SITE: Trumpet Fields adjacent A438, Trumpet, Ledbury HR8 2RA
TYPE: Planning Permission
DESCRIPTION: Erection of polytunnels on fields at Trumpet for covered commercial growing of soft fruit and new pond area
APPLICATION NO: 150765
GRID REFERENCE: OS 366269, 239068
DATE OF THIS RESPONSE: 02/07/15

This response is in regard to the following additional information submitted by the Applicant in June 2015:

Figure 1: Extract from EA's Risk of Flooding from Surface Water Map (July 2015)

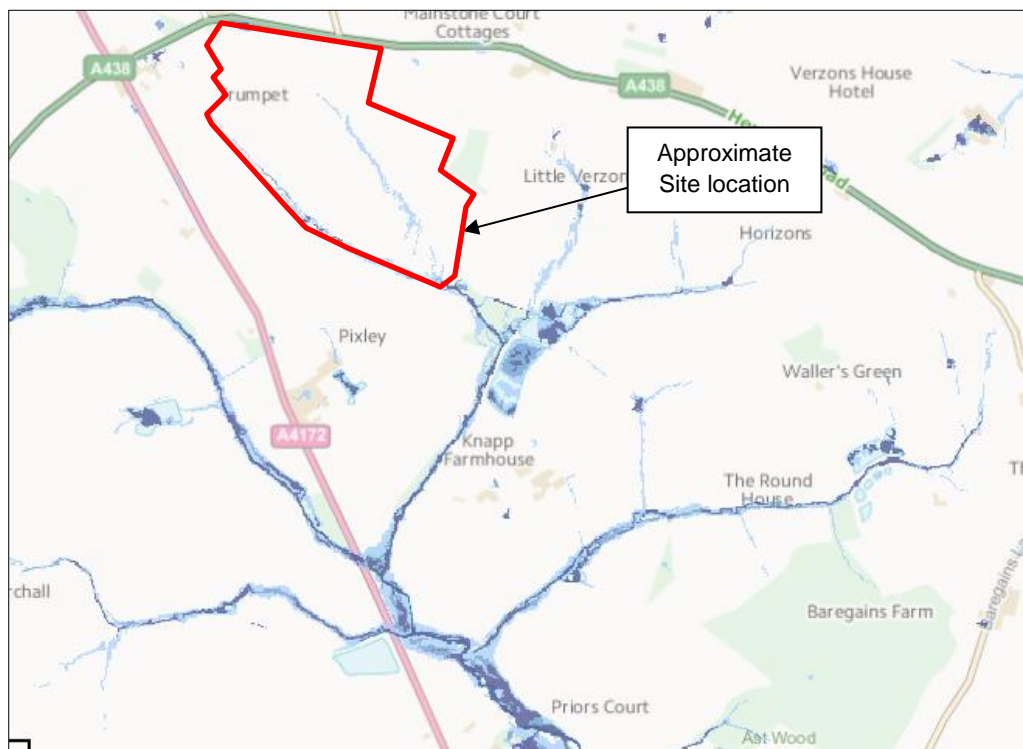
The submitted WMA Addendum includes short statement summarising flood risk assessment at the site. The provided summary statement is found to be satisfactory. It is noted that the Addendum states that Figure 5 of the document shows the EA's Risk of Flooding from Surface Water map, but it shows EA's Flood Map for Planning which indicates extent of fluvial flooding. A review of the EA's Risk of Flooding from Surface Water Map (shown below) indicates a potential low risk flow path through the site.
